Proposed Primary School,
Kishoge, Lucan, Co. Dublin

Stage 1 Road Safety Audit

Document Ref: P22-066-PSW4-RP-001

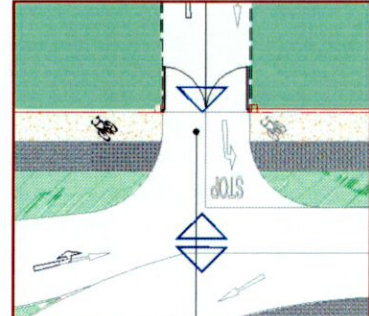
Summary: No changes are proposed to the existing pedestrian and cyclist facilities along Thomas Omer Way to reflect the proposed new priority junction with the westbound carriageway.

It is proposed to construct a new junction onto the westbound carriageway of Thomas Omer Way to facilitate vehicular access to the school development. It is unclear how it is intended to connect the new footpath & cycle tracks along the new school access road to the existing footpath & cycle track along the southern side of Thomas Omer Way. A failure to adequately consider how pedestrians & cyclists will interact at this location could result in conflicts between these road users resulting in pedestrian/cyclist collisions.

In addition, no changes are indicated along the existing footpath and cycle track along Thomas Omer Way. It is therefore unclear how pedestrians & cyclists travelling along Thomas Omer Way will be able to cross the proposed junction.

The layout at the intersection between the new and existing footpath & cycle tracks at the proposed new junction should safely accommodate non-motorised road users travelling through the new junction.

In addition, measures should be provided to cater for the existing pedestrian and cyclist movements along Thomas Omer Way.

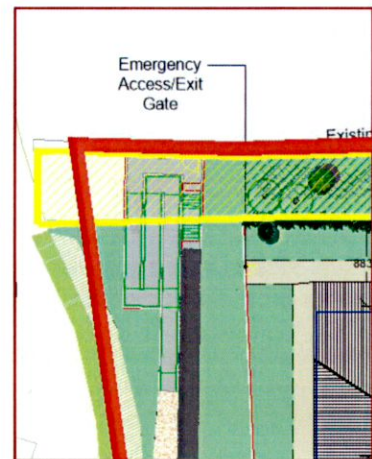
Summary: Discontinuous footpath and cycle track at school car park entrance.

The footpath and cycle track along the northern side of the road immediately south of the proposed school development is indicated as being discontinuous across the entrance to the school car park.

This arrangement prioritises vehicles entering/exiting the car park above non-motorised road users. In addition, inter-visibility between exiting drivers and pedestrians or cyclists approaching the access may be restricted by the boundary wall/fence, possibly resulting in exiting drivers failing to see an approaching pedestrian or cyclist leading to vehicular/NMU collisions.

The footpath and the cycle track should be continuous across the entrance to the school.

The gate to the school, and boundary on either side of the gate, should be set back a sufficient distance to afford adequate inter-visibility between exiting drivers and pedestrians/cyclists approaching along the external footpath/cycle track (e.g. bell-mouth arrangement).

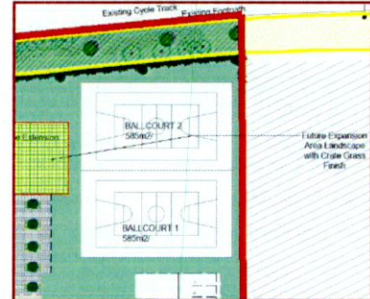
Summary: Unclear if gradients along proposed non-motorised road user ramps will be appropriate for mobility impaired pedestrians.

At this early stage in the design development, it is unclear what gradients are proposed on the proposed non-motorised road user (NMU) ramp to/from the proposed school and Thomas Omer Way, in the north-western corner of the proposed development.

Steep gradients can create difficulties for wheelchair users and pedestrians, particularly the mobility impaired and the elderly, to safely and comfortably navigate the ramps, possibly resulting in slips, trips and falls.

In addition, it is unclear if cyclists travelling along the proposed ramp are intended to dismount and walk along the ramp, or if the ramp is of sufficient width to accommodate cyclists, pedestrians & wheelchair users without cyclists having to dismount.

The gradients & width of the ramps, and the frequency & dimensions of landing areas, should cater for the needs of the mobility impaired (e.g. wheelchair users), as recommended by the National Disability Authority.

In addition, the width of the ramp should be adequate to cater for the expected volumes of pedestrians, cyclists & wheelchair users during peak times.

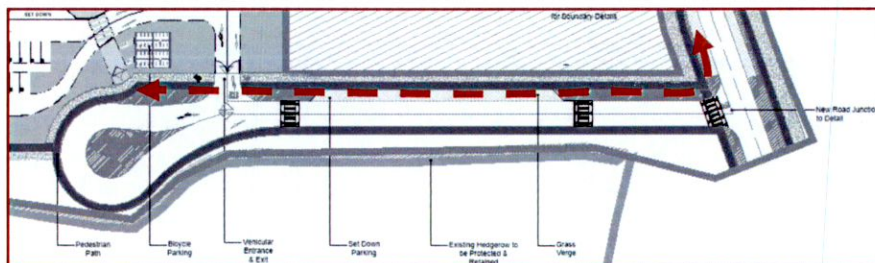
Summary: Floodlighting may create glare for drivers on Thomas Omer Way.

Two "Ball Courts" have been indicated within the proposed development adjacent to Thomas Omer Way. It is unclear from the information provided if it is intended to provide lighting to these courts. If lighting is to be provided care will be required in order to ensure that the lighting does not shine towards, and dazzle, drivers on the adjacent road.

Poorly oriented lighting may create glare for drivers on Thomas Omer Way resulting in drivers being distracted, disoriented or momentarily blinded leading to a temporary inability to see a hazard in the upcoming road, resulting in a failure to stop.

During the design development the proposed lighting provision for the "Ball Courts" should be designed such that it will not result in the dazzling of drivers on the adjacent roads.

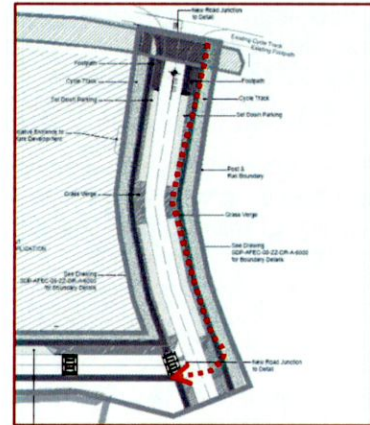
Summary: Unclear if proposed cycle facilities or sufficient width for two-way cycle traffic.

A cycle track is proposed along the northern side of the school access roads, which will presumably cater for both inbound & outbound cyclists.

It is unclear if the proposed width of the cycle track is adequate to cater for the expected volumes of two-way cyclists, possibly resulting in some cyclists entering the adjacent footpath in order to pass oncoming cyclists resulting in increased risk of collisions with pedestrians on the footpath.

The width of the two-way cycle track should be adequate to cater for the expected volumes of cyclists in accordance with guidance provided in the National Cycle Manual.

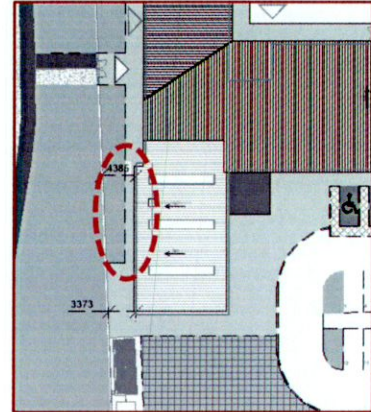
Summary: No crossing facilities for southbound cyclists or students dropped off on the eastern side of the north-south school access road wishing to travel to the proposed school.

No crossing facilities have been indicated of the north-south running School Access Road to the east of the proposed development. The absence of a crossings may result students dropped off on the eastern side of the road within the proposed set-down areas and/or southbound cyclists crossing at unsafe locations. In the case of cyclists, some may choose to travel southbound within the northbound cycle lane, increasing the risk of collisions with other cyclists.

Crossings should be provided to cater for students travelling to/from the set-down & pick-up areas along the eastern side of the proposed new road to the east of the proposed development.

In addition, a two-way cycle track of appropriate width could be provided along the western side of the school access road to the east of the proposed development, and along the northern side of the school access road to the south of the proposed development, which could permit the omission of the cycle track on the eastern side of the access road to the east of the proposed development if it is not required for other reasons.

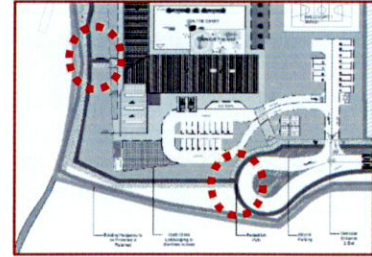
Summary: The footpath along the western side of the school building is narrow and may not sufficiently accommodate the expected volume of pedestrians & cyclists during peak times.

The width of the footpath along the western side of the school building appears to be relatively narrow in places.

This route is the most likely route for cyclists who enter the campus from the north-west wishing to access the bicycle parking locations.

This could lead to pedestrians and cyclists travelling in opposite directions being unable to pass each other within the footpath, resulting in them stepping into the adjacent verge where there is an increased risk of slips and falls, in particular during wet or icy weather.

The footpath at this location, and throughout the proposed development, should be of adequate width to cater for the likely/expected volumes of pedestrians and cyclists during peak times.

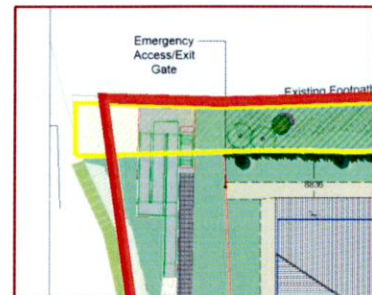
- 4.1 Potential conflict points have been indicated between the proposed footpaths & cycle tracks, in particular on the western side of the proposed development and at the southern entrance into the proposed development.

At these locations cyclists would be required to cross the path of pedestrians, with a resulting potential for conflicts. If possible, during the design development conflict points should be eliminated or reduced.

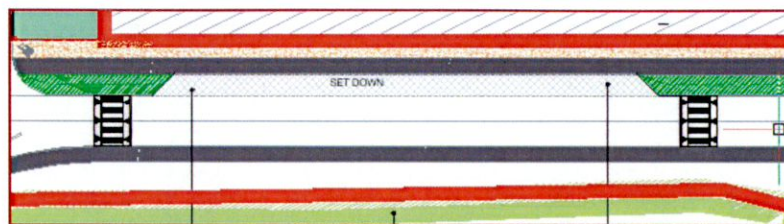
- 4.3 Raised tables have been indicated along the school access road to the south of the proposed development with zebra-crossing markings, however no Belisha beacons have been indicated at these locations and the raised-tables terminate on the northern side at a grass verge.

It is unclear if these raised-tables are intended to be crossings or if their purpose is purely for traffic. Regardless, the zebra-crossing markings should be omitted unless it is intended to provide Belisha beacons, and the other measures required at zebra crossings.

Should there be no crossing desire line at these locations the omission of the markings should be sufficient along with vertical separation between the footpath and the top of the raised-table.

However should a crossing desire exist at these locations the footpath on the northern side should be extended to meet the raised-tables, the top of the raised tables should be flush with the footpath levels on either side and tactile paving provided to warn visually impaired pedestrians of the carriageway risk.
